# RIVERSIDE COUNTY AIRPORT LAND USE COMMISSION

## STAFF REPORT

**CASE NUMBER:** ZAP1028PV23 – Landstar Companies (Representative: Johnson Aviation)

**APPROVING JURISDICTION:** City of Perris

Figure 10 – Building 2 Elevation Range

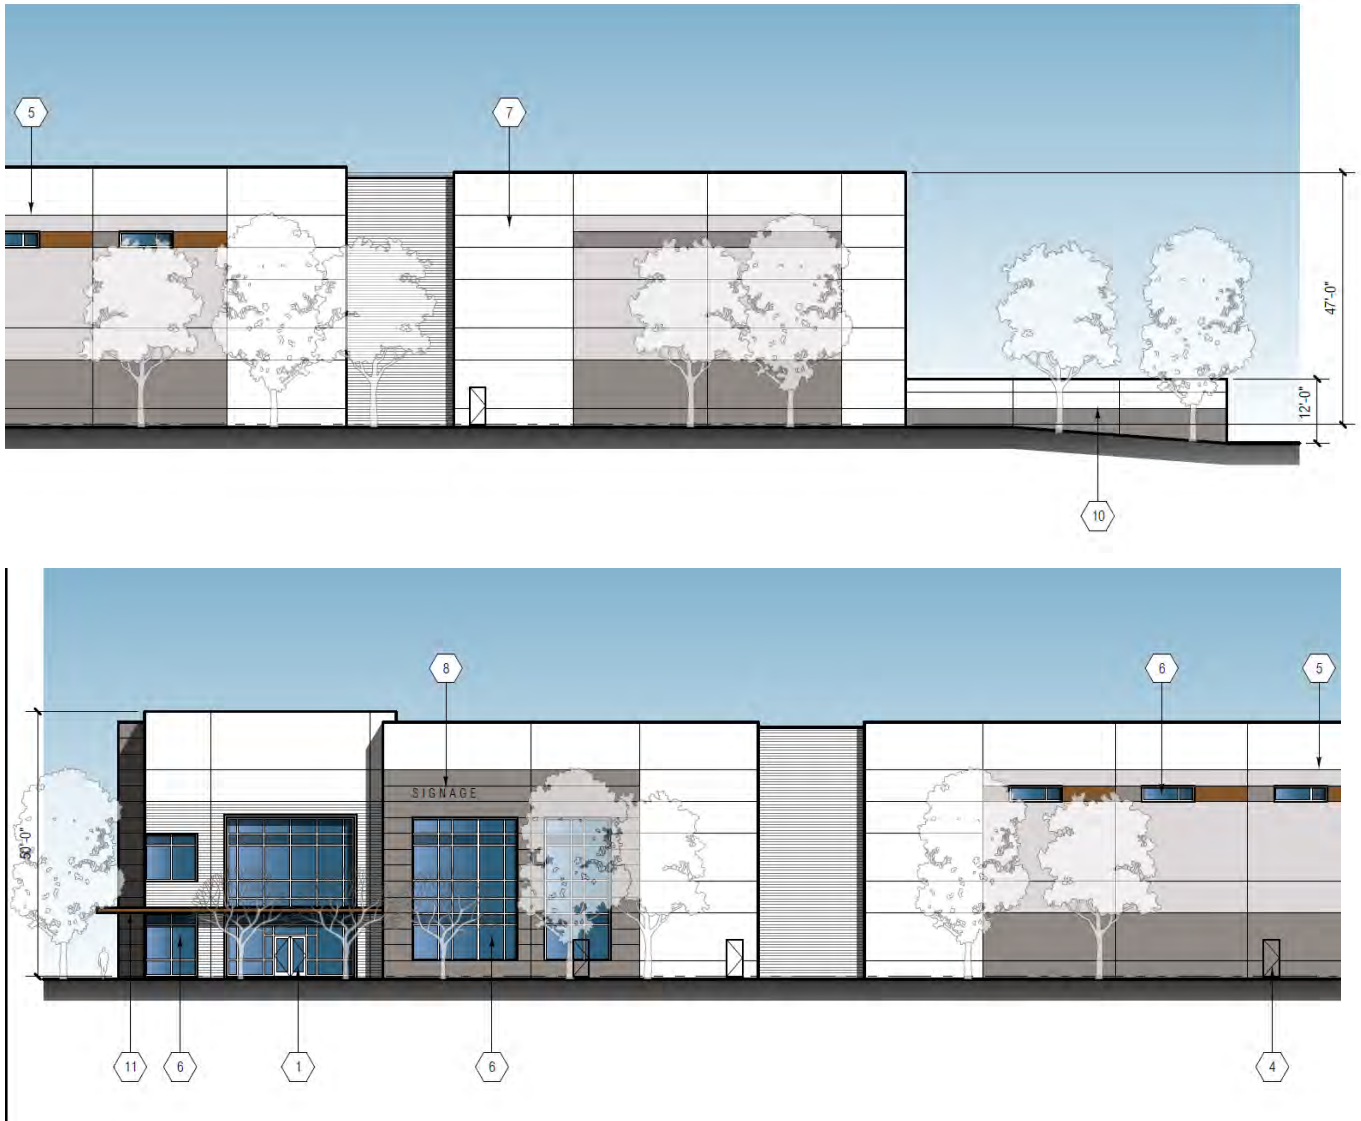
The building height for the larger industrial warehouse (Building 1) ranges from 47 feet to 50 feet to parapet; for the smaller industrial warehouse (Building 2) it is 41 feet to 45 feet to parapet. Figures 9 and 10 show the elevation ranges for both buildings. The ALUCP states that Airspace review is required for objects greater than 35 feet tall in Zones B1 and B2 and for objects greater than 70 feet tall in Zones C and D, however, that is considered general guidance. An aeronautical study by the FAA was initiated for the buildings associated with the Property (Appendix A). The aeronautical study will assess the building locations, planned heights and whether there is a need for any associated lighting or markings to ensure that the buildings are conspicuous at night and during low visibility weather conditions. Within Zone B1 and B2, new buildings are limited to no more than two occupied floors above ground. Within Zone C, new buildings are limited to no more than three occupied floors above ground.
